Access Compliance Report

Public Rights-of-Way

Intersection ID: 15822	Main Street: CHIPPENDALE_RD	Cross Street: TULANE_ST	Location: NW
ADA ID: 0EEE0AE0A0FA	Ramp Type: Para	Initial Pass/Fail: Fail	Overall Compliance: No
			Severity Score: 26.25

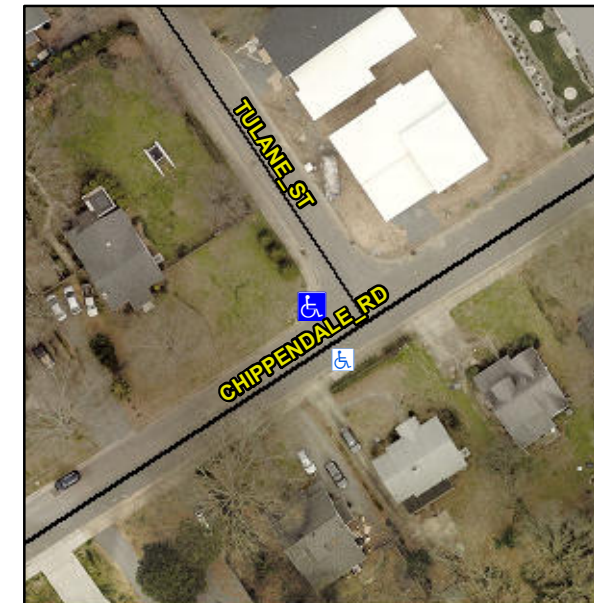
RT RP < 5%

PROW/ADA:

R304.3.2, R304.5.3

Compliance	Description	Data	Compliance	Description	Data
N/A	Ramp Length LT (in)	64.0	N/A	Ramp Length RT (in)	65.5
Yes	Ramp Width LT (in)	59.0	Yes	Ramp Width RT (in)	58.5
No	Ramp Slope LT (%)	12.9	Yes	Ramp Slope RT (%)	0.7
No	Ramp XSlope LT (%)	3.8	Yes	Ramp XSlope RT (%)	0.7
N/A	Landing Length (in)	N/A	N/A	DWS Provided?	N/A
N/A	Landing Width (in)	N/A	N/A	DWS Contrast?	N/A
N/A	Landing Slope (%)	N/A	N/A	DWS Length (in)	N/A
N/A	Landing X Slope (%)	N/A	N/A	DWS Full Width?	N/A
N/A	Landing Curb? (Y/N)	N/A	N/A	DWS Offset (in)	N/A
N/A	Shared Landing?	N/A			
N/A	Gutter Ponding?	N/A	N/A	Gutter Slope (%)	N/A
N/A	Gutter Lip Ht (in)	N/A	N/A	Gutter X Slope (%)	N/A
N/A	Painted X Walk1?	No	N/A	Painted X Walk2?	N/A
	X Walk 1 Direction	To S		X Walk 2 Direction	N/A
N/A	X Walk 1 Width (in)	N/A	N/A	X Walk 2 Width (in)	N/A
	X Walk 1 Slope (%)	0.6		X Walk 2 Slope (%)	N/A
	X Walk 1 X Slope (%)	1.9		X Walk 2 X Slope (%)	N/A
N/A	Ramp inside XWalk1?	N/A	N/A	Ramp inside XWalk2?	N/A

Possible Solutions:

Remove & Replace Entire Ramp.
